DCN No. E040012-00-C

Document Change Notice (DCN)

DOCUMENT No. (DOC-REV-GP.ID)	TITLE	NEW REV
D030168-A	LOS Coil DAQ Whitening board	A2

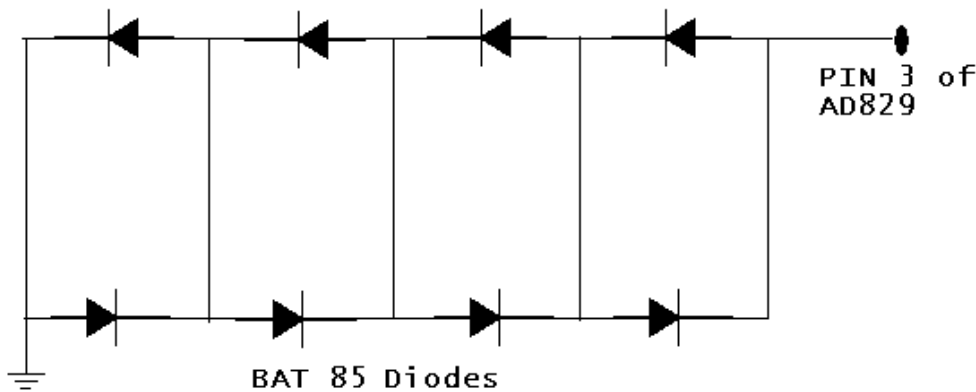
Construct 4 clamper circuits (shown below) using Qty: 8, Type: BAT 85, diodes per clamper (total Qty: 32 for all 4 channels).

BAT 85 Diodes

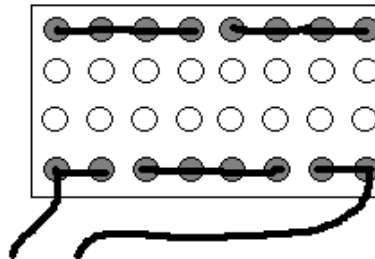
Suggested construction is on tiny 4X8 perf-boards that will fit under the shield and provide access to other components if any future testing and/or troubleshooting is needed (see picture)
